UNITED STATES PATENT AND TRADEMARK OFFICE

APPLICATION NO.	FILING DATE	FIRST NAMED INVENTOR	ATTORNEY DOCKET NO.	CONFIRMATION NO.
10/602,547	06/24/2003	Kyle Bateman	2280.ACTI.NP	1226
27472 7590 04/18/2007 RANDALL B. BATEMAN BATEMAN IP LAW GROUP 8 EAST BROADWAY, SUITE 550 PO BOX 1319 SALT LAKE CITY, UT 84110			EXAMINER CHAMBERS, TROY	
			ART UNIT 3641	PAPER NUMBER
SHORTENED STATUTORY PERIOD OF RESPONSE		MAIL DATE	DELIVERY MODE	
3 MONTHS		04/18/2007	PAPER

Office Action Summary

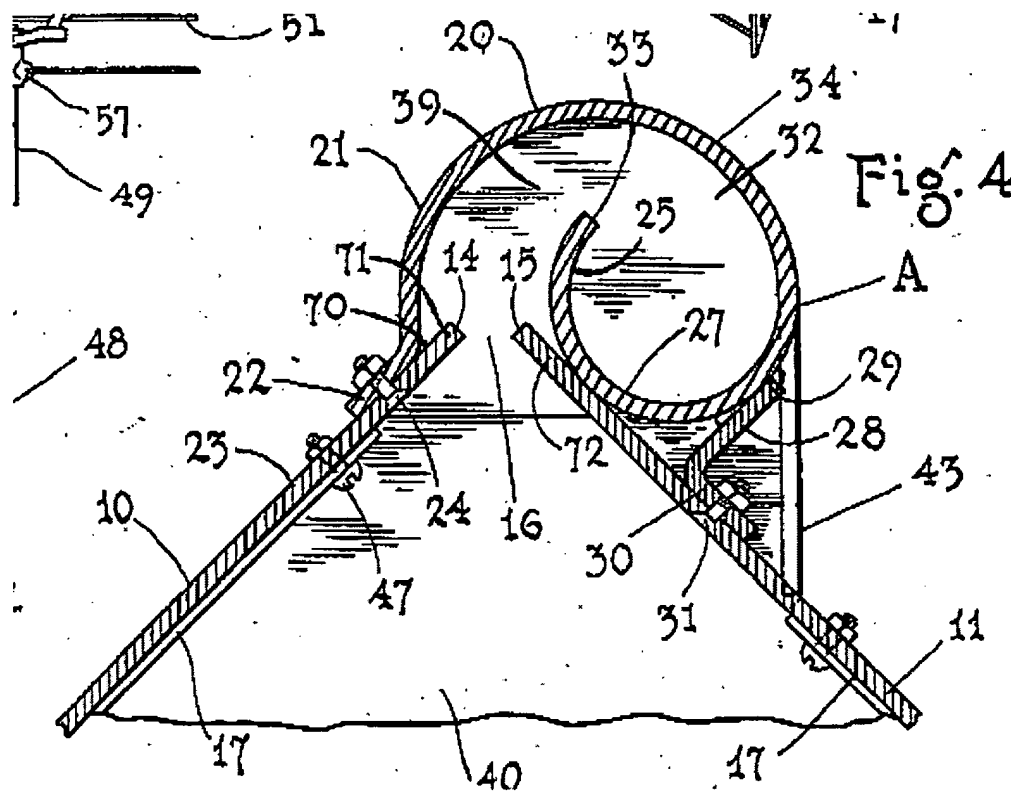
1. Gonzalez discloses a modular ballistic wall, comprising:
 - a. first and second steel plates (steel shading) 12
 - b. facing strip 18
 - c. a backing strip 34

d.	an arm/mounting brackets	26
e.	bullet containment frame	10
f.	holes (keyholes)	
g.	bolts	16
h.	nuts	20

Gonzalez does not appear to disclose the hole and slot configuration claimed by the applicant. However, the Examiner takes Official notice that it is well known to use the hole and slot configuration as claimed by the applicant. At the time of the invention, one having ordinary skill in the art would have found it obvious to provide the device of Gonzalez with the hole and slot configuration; the suggestion/motivation for doing so would have been to allow for the relatively easy alignment of the various plates and facing strips with respect to one another.
